# CITY OF SAINT PAUL

## HERITAGE PRESERVATION COMMISSION STAFF REPORT

**FILE NAME:** 504 Selby Avenue  
**INVENTORY NUMBER:** RA-SPC-3249  
**APPLICANT:** Richard Laffin  
**DATE OF PUBLIC HEARING:** September 21, 2020  
**HPC SITE/DISTRICT:** Hill Heritage Preservation District  
**PERIOD OF SIGNIFICANCE:** 1858-1930  
**CATEGORY:** Contributing **WARD:** 4 **DISTRICT COUNCIL:** 13  
**ZONING:** RM2 **CLASSIFICATION:** Storefront  
**STAFF INVESTIGATION AND REPORT:** George Gause

Proposed North Elevation and Plan View

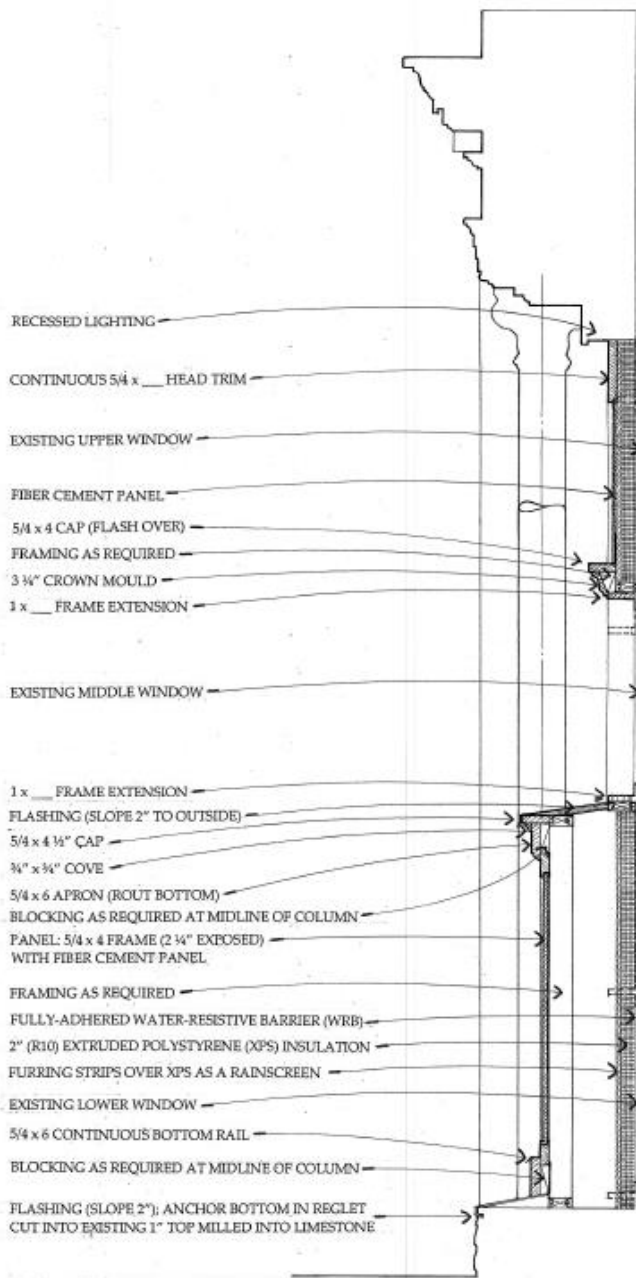
**Question: What is the purpose of the heavy horizontal piece that runs across the front? Can it be reduced into the storefront area more?**

The accompanying section detail indicates the relative planes of the various parts of millwork.

The proposed design steps out twice by about 20" from the existing vertical plane of the windows to the stone base below. The upper step is represented by the horizontal trim band you mention. It is really nothing more than a flashed sloped surface from the back plane with a cap and apron at the intermediate plane. You can see from the elevation and detail that the millwork is to be located at the midline of the columns so that the front halves of the columns are fully expressed from the top to bottom. The columns are only 6 3/4" in diameter, which we feel is overly slender, the size one might expect in Italianate architecture. We would like to buttress them visually so that they don't look quite so spindly. To your point, the trim band is set well back from the existing principal millwork band above.

As you know, the first floor of the building has bands of upper, middle, and lower windows. The middle-height windows have typical head heights (inside), but they appear curiously low because of the upper windows, and they float visually. We think that the head trim you indicate with an arrow moors them and gives them just enough prominence, so they don't look like a mistake. The proposed trim is a greatly-scaled-down version of the cornice trim above.
